# Belt tensioner 534 0314 10

## Tensioning arm with integrated vibration damper

Manufacturer: Citroën

Part no.: 534 0314 10 (new)  
533 0090 10 (replaced)

Photo 1: 534 0314 10 – Belt tensioner for V-ribbed belts

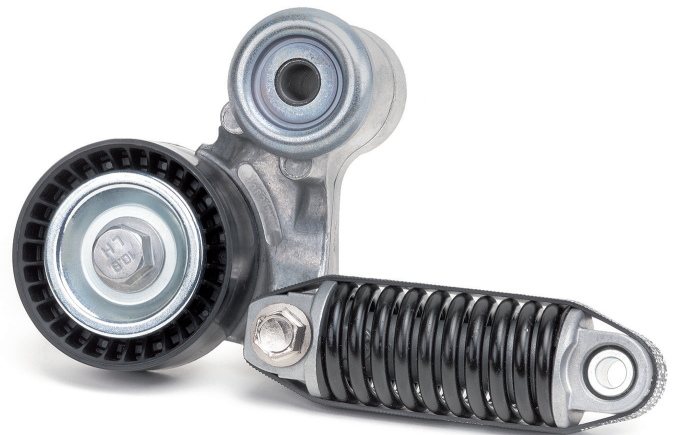
Belt tensioner 533 0090 10 (fig. 2) and the accompanying roller of the tensioning arm are subject to the same wear. Therefore from a technical point of view, it makes sense to replace both components at the same time. For that reason, Schaeffler Automotive Aftermarket offers belt tensioner 534 0314 10 (fig. 1) only as a complete assembly.

Vibration damper 533 0090 10 (fig. 2) is no longer available separately.
